Technical Bulletin

Model: Model CV-P1 No.: RM000001a Date: 18-Apr-08

Subject: Firmware Release Note: Engine			Prepared by: Y.Gaman		
From: 2nd Tech. Support Sec. Service Support Dept.					
Classification:	Troubleshooting	☐ Part informat	tion		
	☐ Mechanical	☐ Electrical		☐ Service manual revision	
	☐ Paper path	☐ Transmit/rec	eive	☐ Retrofit information	
	Other ()

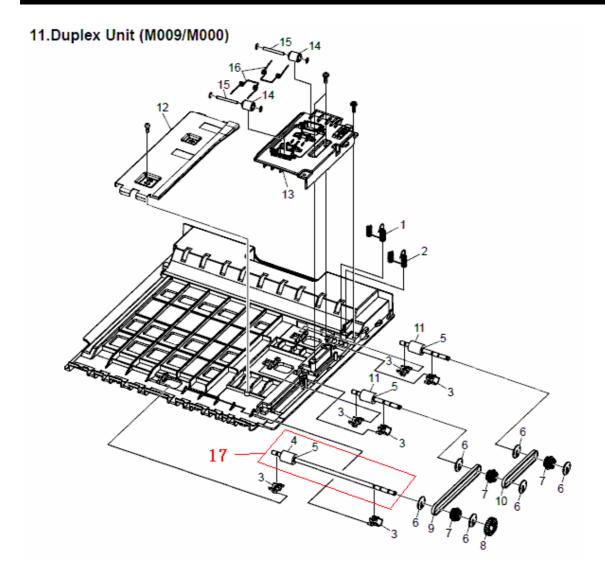
Change: These parts were combined into one assembly.

Reason: The parts vendor stopped supplying P/N M0001144 as an individual part.

Old Part Number	New Part Number	Description	Q'ty	Int	Page	Index	Note
M0001144	M0001603	RZL: ELAUNIT-DUP2	1	0/0	ď	4 →17	_
M3071033	100001000	NZL. LLAUNII-DUF Z	'	0/0	3	5 →17

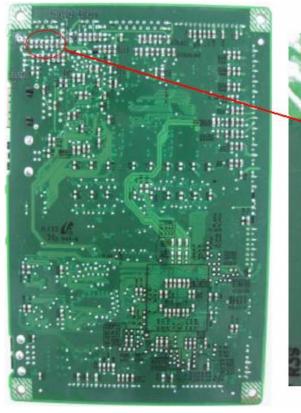
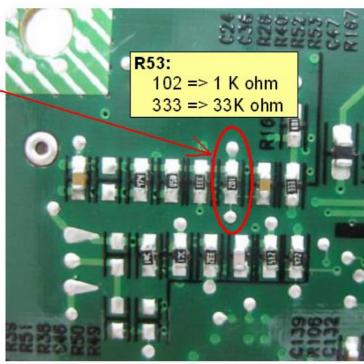
One of the following occurs, which causes the surfaces of the hot roller and pressure roller to partially melt:

- 1. Thermistor malfunction: Spot welding was incorrectly applied to the thermistor.
- 2. Unstable power supply: This can create excess electrical noise (and surge current, in some cases), which interferes with the function of the fusing unit.
- 3. Damage to the thermistor harness: This can happen if the harness is caught in the rib of the side cover when the side cover is attached in the field.

1. Thermistor malfunction:

Upgrade to Engine firmware ver1.50.01.35 or newer

Note: *In addition to improved fusing temperature control,* this firmware version includes solutions for other thermistor-related issues as well. The new fusing temperature control limits the fusing ON time, which prevents the fusing heater from staying ON too long, even if the thermistor malfunctions.

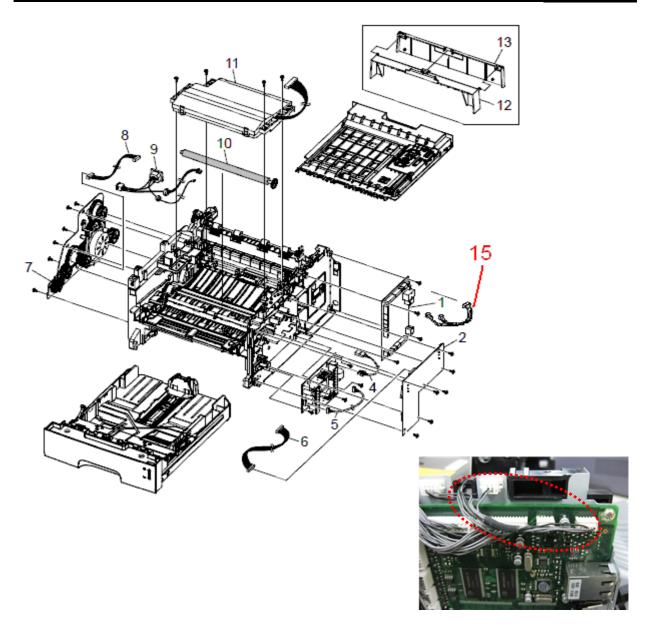
Change: This part was added. **Reason:** To make it possible to replace this part in the field (See RTB No. RM000003 for

details).

NEW Part	Description	Q'ty	Int	Page	Index	Note
M0001604	HARNESS-JNT:THERMISTOR	1	1	3	15

12.Cassette Unit (M009/M000)

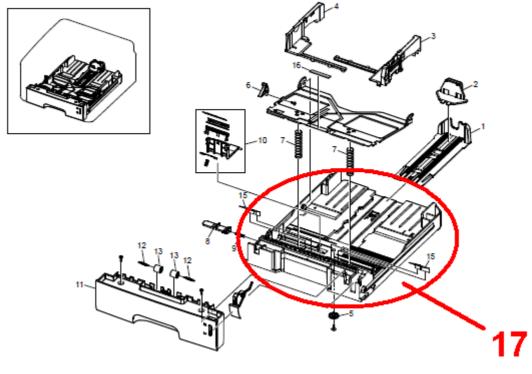
Change / Reason:

The new service part is added because of a request from the field.

Part No.	Description	Q'ty	Int	Page	Index	Note
M0001040	FRAME:CASSETTE:JC61-00876L	1	-	25	17	_

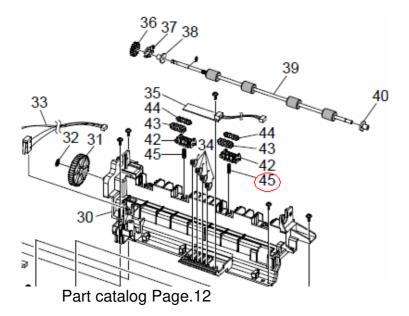
A wrong part number was found in part catalog Page.13 Index No.45.

Index No.	Correct Part No.	Description	Q'ty
45	M0001015	Spring CS	2

Page 24 of Parts Catalog:

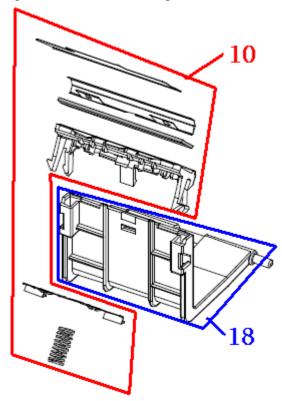
Change:Added a new part and changed the assembly of a part described below.

Part Number	Description	Q'ty	Page	Index	Note
M0001176	Housing:Pad Holder	1	25	10	Ass'y is changed
M0001043	Pad Holder	1	25	18	Newly added.
